TO: <b>SUPERSEDED BY EI 84-035</b> <b>EFFECTIVE 7/13/84</b>	<h1 style="text-align: center;">ENGINEERING INSTRUCTION</h1> <p style="text-align: center;">NEW YORK STATE DEPARTMENT OF TRANSPORTATION</p> <p>SUBJECT: BRIDGE DESIGN MANUAL          STANDARD DETAILS FOR HIGHWAY BRIDGES          REPLACEMENT CLAMPS FOR STEEL BRIDGE RAILING</p> <p>Subject Code: 7.35-5-1</p>
Distribution: <input checked="" type="checkbox"/> Main Office <input checked="" type="checkbox"/> Regions <input type="checkbox"/> Special	Code: EI 82-54 Date: Aug. 13, 1982
APPROVED: <i>E.V. Bourigan</i> E.V. Bourigan, Deputy Chief Engineer (Structures)	Supersedes: E.I. 82-13 E.I. 82-35

Subject: REPLACEMENT CLAMPS FOR STEEL BRIDGE RAILING

DETAIL # 1

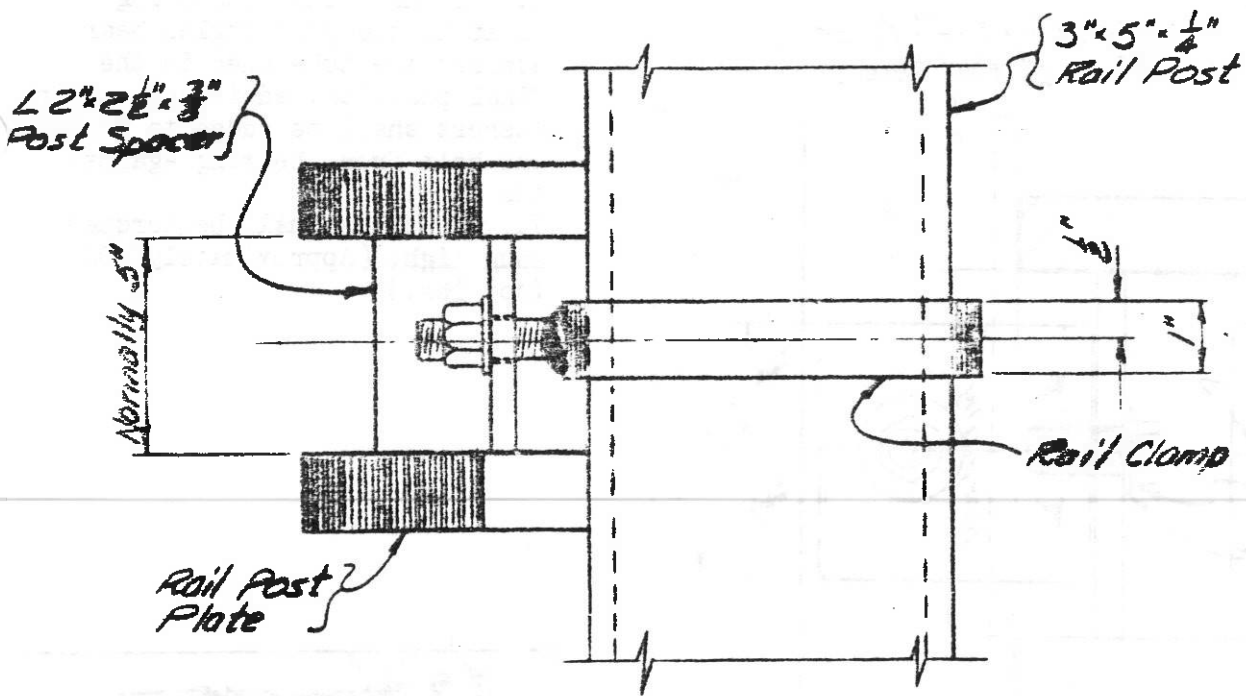
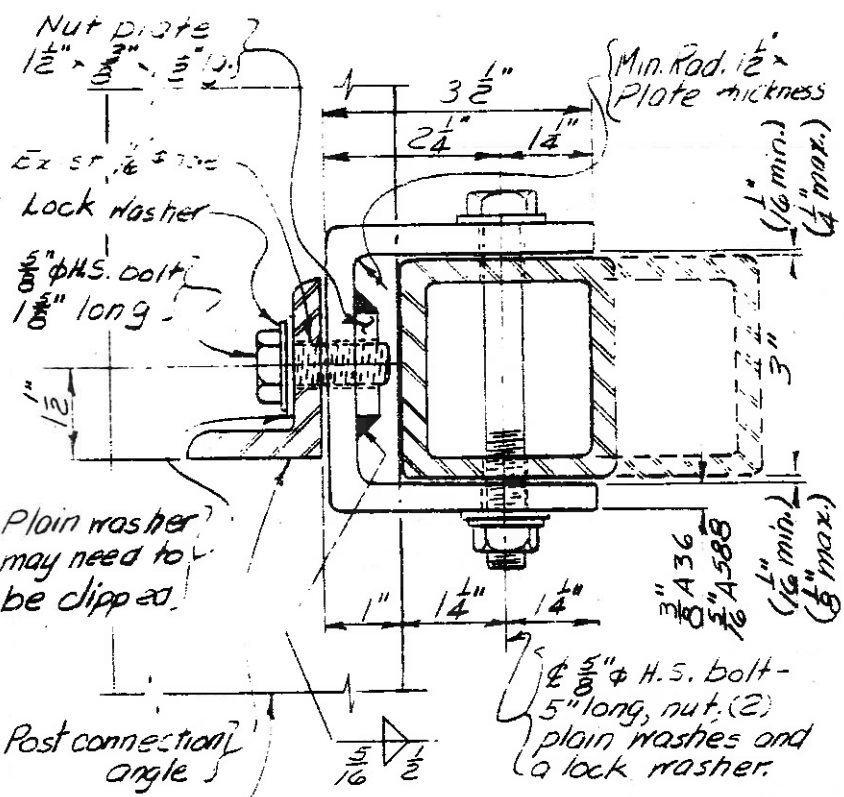
Several years ago, it was determined that the railing clamps used on two and four rail steel bridge railing installed between the mid 1960's and the mid 1970's (see attached Detail 1) were a serious maintenance liability. The clamps were easily broken when impacted by snow plow blades, resulting in loss of support for the railing tube. In some cases, the loss of support allowed the railing tube to drop to the bridge sidewalk or deck. In addition, the weld attaching the stud to the clamp had frequently found to be broken as a result of thermal stresses and/or stresses resulting from minor impacts. This break usually went unnoticed, because the railing tube was rigid enough to span between several broken clamps. At times of significant impact the railing tube could have been displaced upward or downward because it was not being properly restrained. The broken clamp, or broken weld, renders the railing tube ineffective for its intended purpose.

Effective immediately, rail clamps of the type depicted in Detail 1 shall be replaced by clamps as shown in Detail 2R on all bridge rehabilitation projects where encountered. Specification No. 15587.05 "Steel Bridge Railing Replacement Clamp", shall be used when clamp replacement is a part of a project. A copy of the specification is attached for your use and will be stocked as a Main Office insert. The clamp shown in Detail 2, issued with EI 82-13, and the one shown on Detail 2R, issued with this Issuance, are the same; some notes have been removed from Detail 2R because they are included in the specification.

STATE OF NEW YORK  
 DEPT. OF TRANS.  
 ST. BR. RAILING  
 REPLACEMENT CLAMP  
 DETAILS

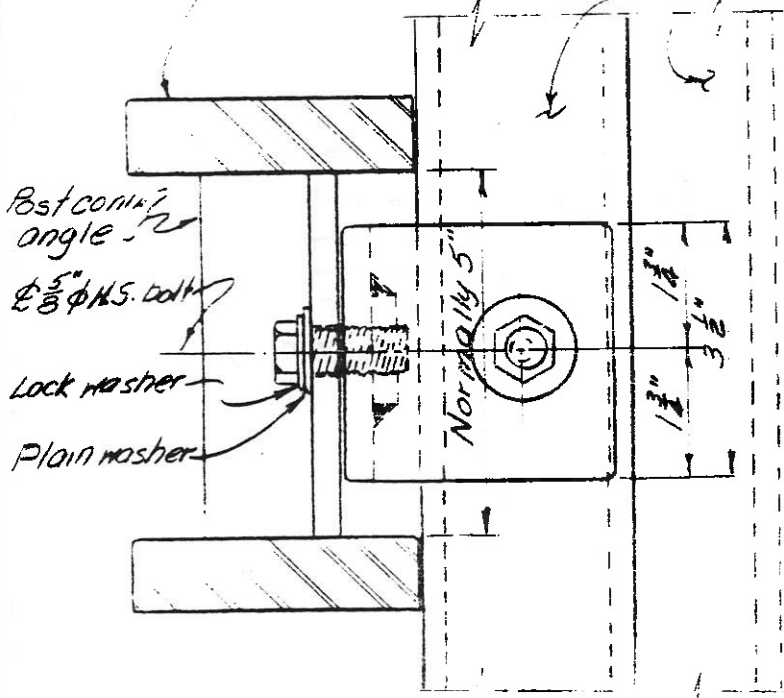
For this reason a new clamp was designed and made a part of the standard details for new railings. However, this clamp did not fit railing systems installed between the mid 1960's and the mid 1970's. Therefore, a third clamp was developed (see attached Detail 2R) for retrofitting railing systems built during that period. A similar clamp has been used by the Highway Maintenance Division for several years. In addition, the details for the third clamp were informally distributed to designers, on a job-by-job basis, in both the Main Office and Regional Offices for use on rehabilitation contracts.

Designers should assure themselves that the replacement clamps will fit the railing systems on which they are to be used. Railing systems may be encountered which were not built according to the contract documents. These will require adaptations of the clamp shown in Detail 2R.

1. Chamfer all edges and corners of the clamp 1/16" by grinding prior to galvanizing so that all sharp edges are removed.
2. All dimensions related to the fabrication of the clamp shall have a tolerance of 1/8" after galvanizing.

3. Locate and punch two (2) 3/4" Ø holes in the top and bottom legs of the rail clamp as shown on this sheet.
4. Using the prepunched holes in the top and bottom leg of the clamp as a guide, drill a 11/16" Ø hole in the top and bottom of of the rail tube. Any damage to the galvanizing caused by the drilling operation shall be repaired according to Material Spec. 719-01.

5. Drill and tap the nutplate and vertical leg of the railing clamp to accommodate the 5/8" Ø H.S. bolt after welding together.
6. If the bolts connecting the clamp to the post angles bear against the tube when in the final position, additional plain washers shall be added to prevent the bolt from bearing against the tube.

7. The bolts shall be torqued snug tight (Approximately 100 foot lbs.)
